Access Compliance Report

Public Rights-of-Way

(Curb Ramps)

Intersection ID: 14547	Main Street: EAST_BV	Cross Street: SPRINGDALE_AV	Location: SW
ADA ID: 40290422CE11	Ramp Type: Perp	Initial Pass/Fail: Fail	Overall Compliance: No
Severity Score: 13.75			
Codes/Mitigation Info/Possible Solution		Field Measurements/Component Compliance

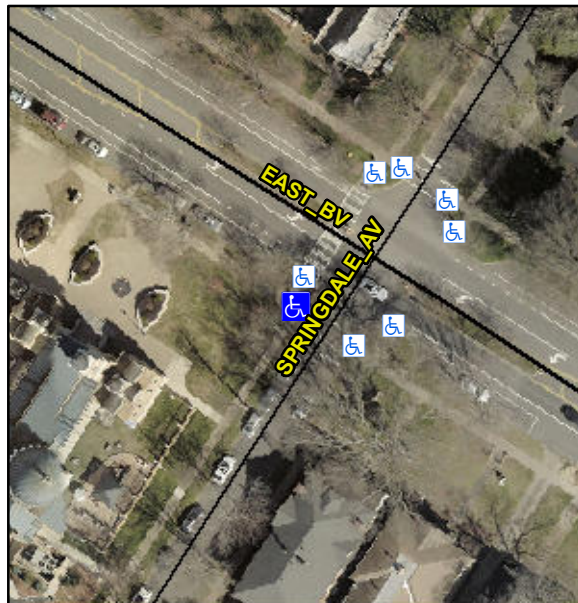
Not Found, R304.2.2, R304.5.3

Compliance	Description	Data	Compliance	Description	Data
N/A	Ramp Length (in)	83.0	No	Ramp Slope (%)	8.7
Yes	Ramp Width (in)	71.0	No	Ramp XSlope (%)	2.1
N/A	Flare Type LT	N/A	N/A	Flare Type RT	N/A
N/A	Flare Slope LT (%)	N/A	N/A	Flare Slope RT (%)	N/A
N/A	Flare Traversable LT?	N/A	N/A	Flare Traversable RT?	N/A
N/A	Landing Length (in)	N/A	N/A	DWS Provided?	N/A
N/A	Landing Width (in)	N/A	N/A	DWS Contrast?	N/A
N/A	Landing Slope (%)	N/A	N/A	DWS Length (in)	N/A
N/A	Landing X Slope (%)	N/A	N/A	DWS Full Width?	N/A
N/A	Landing Curb? (Y/N)	N/A	N/A	DWS Offset (in)	N/A
N/A	Shared Landing?	N/A			
N/A	Gutter Ponding?	N/A	N/A	Gutter Slope (%)	N/A
N/A	Gutter Lip Ht (in)	N/A	N/A	Gutter X Slope (%)	N/A
N/A	Painted X Walk1?	Yes	N/A	Painted X Walk2?	N/A
	X Walk 1 Direction	To SE		X Walk 2 Direction	N/A
N/A	X Walk 1 Width (in)	112.0	N/A	X Walk 2 Width (in)	N/A
	X Walk 1 Slope (%)	0.9		X Walk 2 Slope (%)	N/A
	X Walk 1 X Slope (%)	1.4		X Walk 2 X Slope (%)	N/A

Remove & Replace Entire Ramp.
